RESTRICTIVE COVENANT AMENDMENT REVIEW SHEET

CASE: C14-91-0015(RCA)
Champion Commercial Development

ADDRESS: 5617 FM 2222

Date: April 12, 2011
To: Clark Patterson, Case Manager
CC: Kathy Hornaday, P.E., PTOE
HDR Engineering, Inc.
Reference: Champion Commercial Development, C14-91-0015(RCA)

Sight Distance Calculations

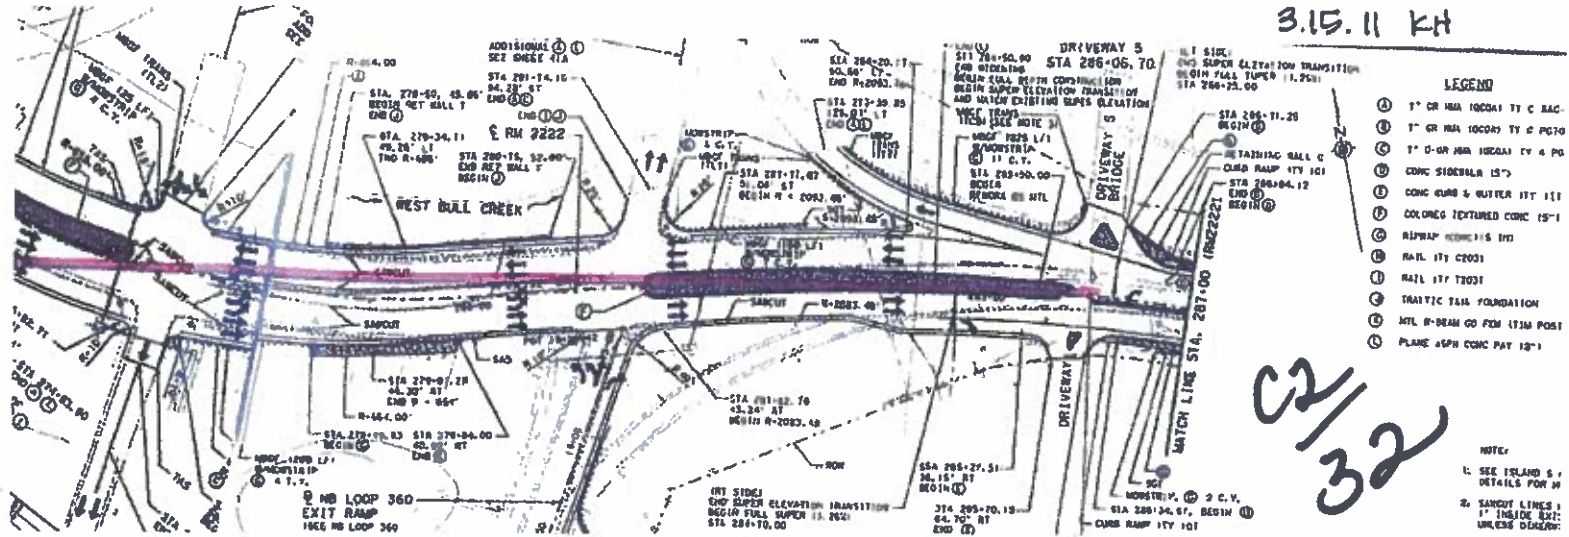
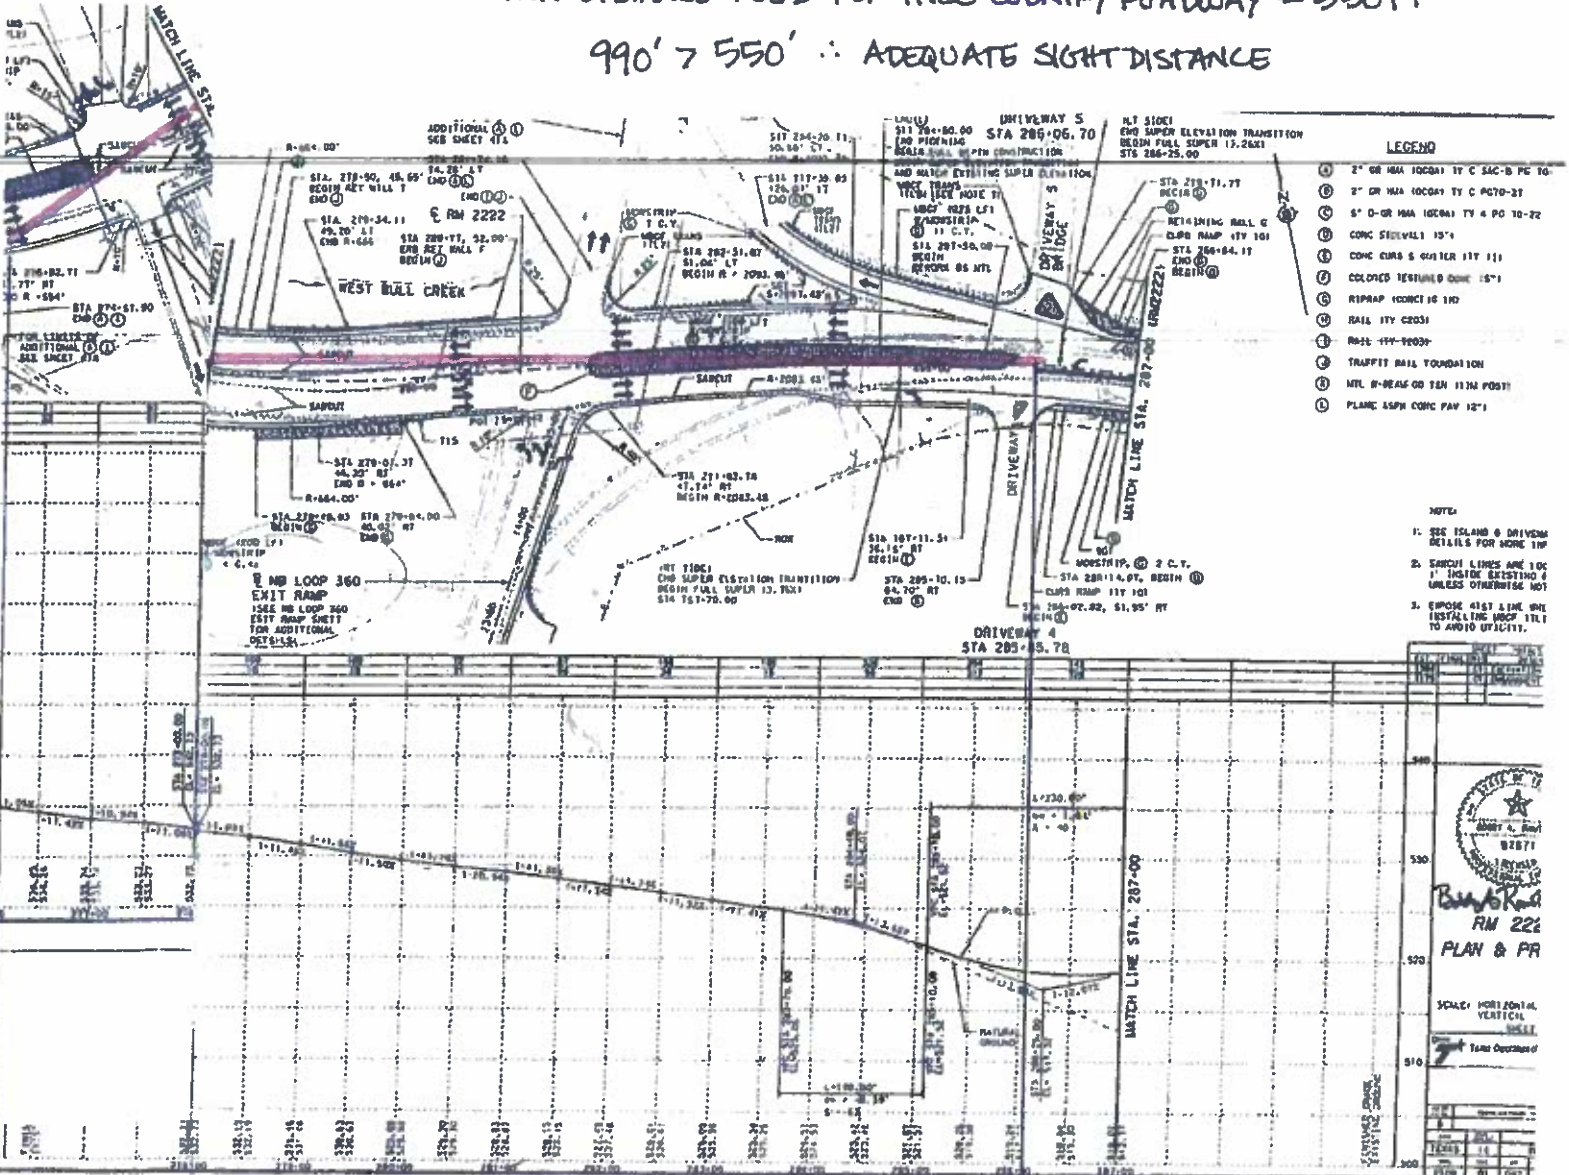
- SIGHT DISTANCE REQ'D FOR RIGHT TURN FROM A STOP, WITH 55 MPH
DESIGN SPEED = ~~445~~ 530 FT

- SIGHT DISTANCE REQ'D FOR HILL COUNTRY ROADWAY = 550 FT

990' > 550' ∴ ADEQUATE SIGHT DISTANCE

Figure 1
RM 2222 Proposed Lane Configuration

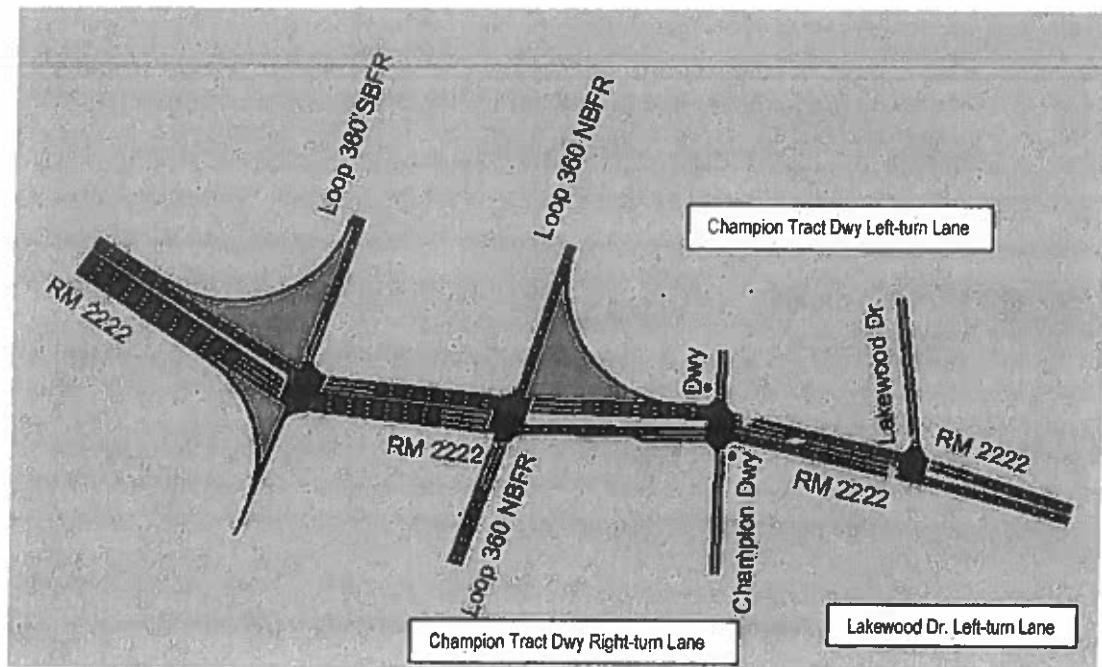
As shown in Figure 1, the Champion Tract driveway on RM 2222 will be aligned with an existing driveway to a retail center on the north side of RM 2222. This driveway is a right-in/right-out only driveway. Counts were not available for this location; therefore, traffic to and from this retail center was estimated given the land use present on the site, which includes 14,600 square feet of quality restaurant, 8,330 square feet of high turnover restaurant, and 4,070 square feet of shopping center. (Trip generation information is enclosed.) The retail center also has an access driveway (not depicted) on Loop 360 Northbound Frontage Road, north of RM 2222. For clarification, the 2007 turning movement counts used for this analysis do include traffic generated by this retail center, since it was occupied at that time; however, counts for the driveway itself are not available. Therefore, traffic from this retail center was not added to the intersections listed above.
